From: Greg Minikel
Sent: Thursday, May 11, 2023 2:58 PM
To: Steven Czekala - D9
Cc: Dan Koski; Sonja Birr; Mackenzie Reed; Jennifer Swokowski
Subject: PI Comm. Document #23-0387 - 631 N. Water St. - Request for City to Pay for Driveway Due to Change to 2-Way Traffic
Attachments: IMG_1753.JPG; IMG_1755.JPG; 631 N. Water St. - Driveway Cost Estimate from Brandon's Concrete Services.pdf; 20230510113908860.pdf; 20230510113244565.pdf

We have looked at the driveway and driveway approach request for 631 N. Water St. and we have several concerns after receiving new information:

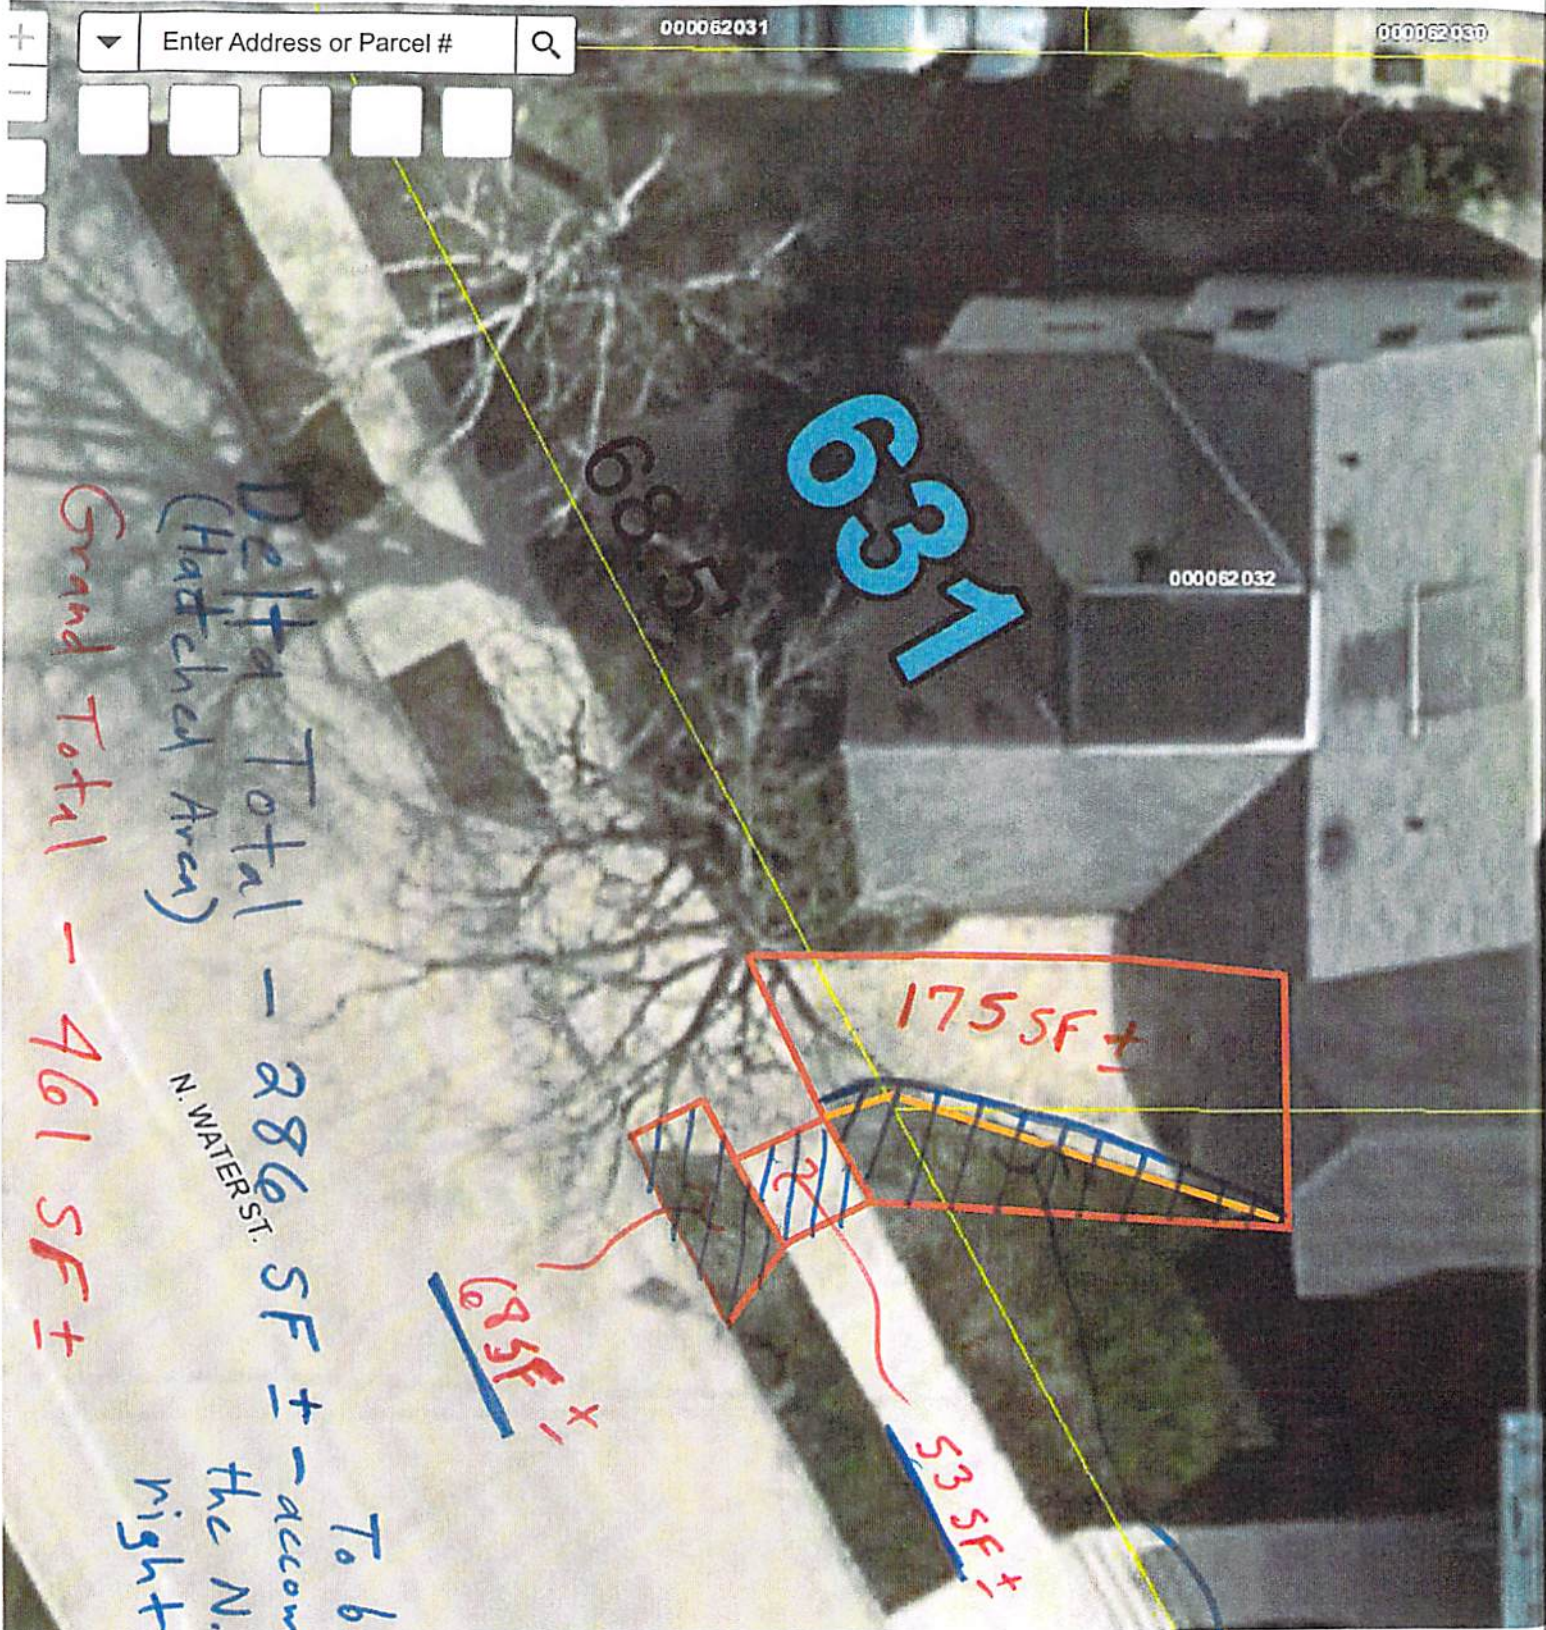
The existing private driveway from the back of the sidewalk to the garage is in horrendous condition. See attached photos.
